Access Compliance Report

Public Rights-of-Way

(Curb Ramps)

Intersection ID: 43146	Main Street: EASTWAY_DR	Cross Street: EASTWAY_DR_RA	Location: SW
ADA ID: DFE23E09B8A8	Ramp Type: Perp	Initial Pass/Fail: Fail	Overall Compliance: No
Severity Score: 46.25			
Codes/Mitigation Info/Possible Solution		Field Measurements/Component Compliance

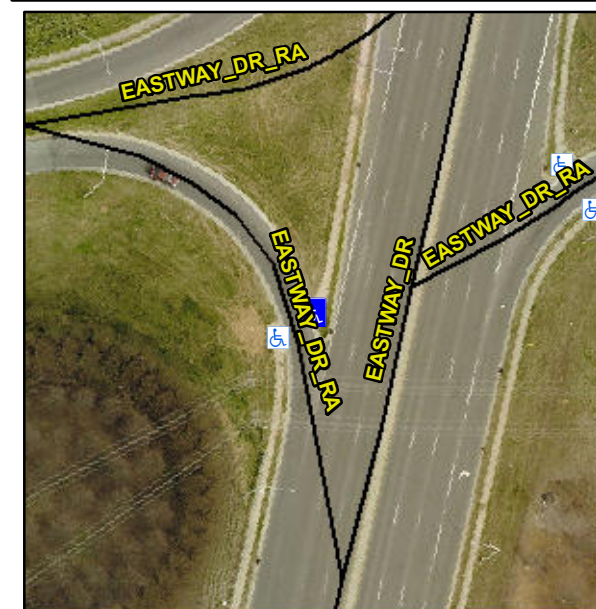
Not Found, R304.5.1, R304.2.2, R304.5.3

Compliance	Description	Data	Compliance	Description	Data
N/A	Ramp Length (in)	37.0	No	Ramp Slope (%)	13.8
No	Ramp Width (in)	40.0	No	Ramp XSlope (%)	5.6
N/A	Flare Type LT	N/A	N/A	Flare Type RT	N/A
N/A	Flare Slope LT (%)	N/A	N/A	Flare Slope RT (%)	N/A
N/A	Flare Traversable LT?	N/A	N/A	Flare Traversable RT?	N/A
N/A	Landing Length (in)	N/A	N/A	DWS Provided?	N/A
N/A	Landing Width (in)	N/A	N/A	DWS Contrast?	N/A
N/A	Landing Slope (%)	N/A	N/A	DWS Length (in)	N/A
N/A	Landing X Slope (%)	N/A	N/A	DWS Full Width?	N/A
N/A	Landing Curb? (Y/N)	N/A	N/A	DWS Offset (in)	N/A
N/A	Shared Landing?	N/A			
N/A	Gutter Ponding?	N/A	N/A	Gutter Slope (%)	N/A
N/A	Gutter Lip Ht (in)	N/A	N/A	Gutter X Slope (%)	N/A
N/A	Painted X Walk1?	No	N/A	Painted X Walk2?	N/A
	X Walk 1 Direction	To S		X Walk 2 Direction	N/A
N/A	X Walk 1 Width (in)	N/A	N/A	X Walk 2 Width (in)	N/A
	X Walk 1 Slope (%)	5.2		X Walk 2 Slope (%)	N/A
	X Walk 1 X Slope (%)	3.3		X Walk 2 X Slope (%)	N/A

Remove & Replace Entire Ramp.
